**Consumers
Power
Company**

MIDLAND NUCLEAR PLANT
UNIT NO 1, DOCKET NO 50-329
UNIT NO 2, DOCKET NO 50-330
POWER SUPPLIES TO EMERGENCY CORE COOLING ACTUATION SYSTEM (ECCAS)
FILE: 0.4.9.40 UFI: 02210 (s) SERIAL: 9311

Subject: NCAR 30 (Issued 6/13/80)
Power Supplies to Emergency Core Cooling Actuation System (ECCAS)
Final Report

Project: Consumers Power Company
Midland Plant Units 1 & 2
Bechtel Job 7220

TWO BATTERY SCHEME

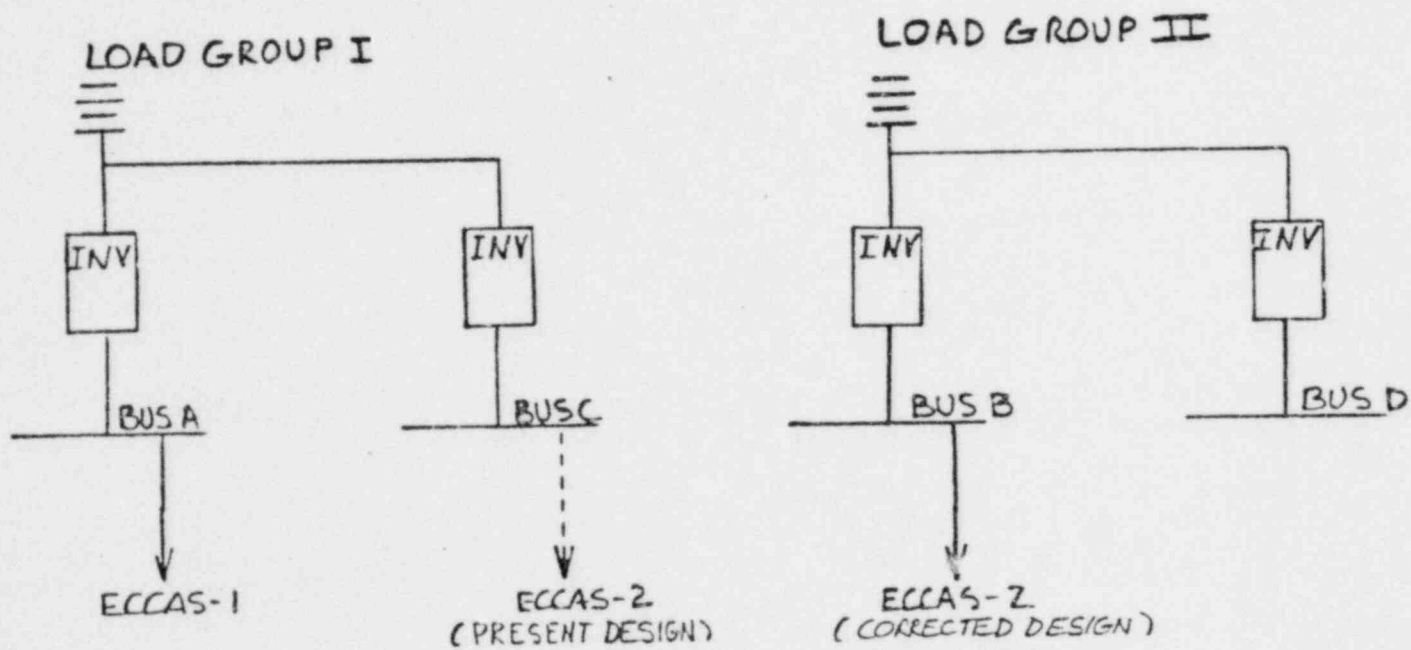
During the course of review of B&W drawing 02-5264 MD-03 (V.P. 7220-M1.32-6-5) by Bechtel, it was noted that the power supply to the ECCAS digital subsystem 1 is shown from vital bus A and the supply to ECCAS digital subsystem 2 is shown from vital bus C. The drawing also shows a -15 volt control signal to ECCAS digital subsystem 2 from ECCAS analog subsystem 3. Subsequent review of Bechtel schematic 7220-E-374(C) revealed the same situation. In accordance with the requirements of sect. 3.3.3 of B&W balance of plant criteria for plant electric system (B&W document 36-1004513-00, V.P. 7220-M1.J-1-1) and TSAR figure 7.2-1 (ECCAS block diagram), the ECCAS digital subsystem 1 should be powered from vital bus A and ECCAS digital subsystem 2 from vital bus B. The -15 volt control signal to ECCAS digital subsystem 2 should be from ECCAS analog subsystem 2.

Thus, based on the B&W drawing and the Bechtel schematic, a postulated event assuming a loss of power from the common load group coincident with a failure of the associated battery, would result in a loss of power to both ECCAS digital subsystems, since both buses A and C would be lost simultaneously (see attached figure).

The apparent cause of this discrepancy was due to a misinterpretation of the Midland plant 120 Vac preferred (vital) power system, specifically the electrical load grouping. The Midland 120 Vac preferred power system, which powers the ECCAS, is served by a two battery scheme, where each battery serves two protection channel buses.

The attached Figure shows the two battery scheme with the corresponding bus labeling and ECCAS digital subsystem bus assignments.

This letter is the Final Report on this matter in that the Bechtel design drawings have been corrected. B&W will have their drawings corrected by September 30, 1980. The ECCAS has not been installed. The only in-place hardware affected consists of three cables, two of which have been terminated. The revised Bechtel Design Drawings deleted these circuits. The Plant will be in conformance by September 30, 1980.
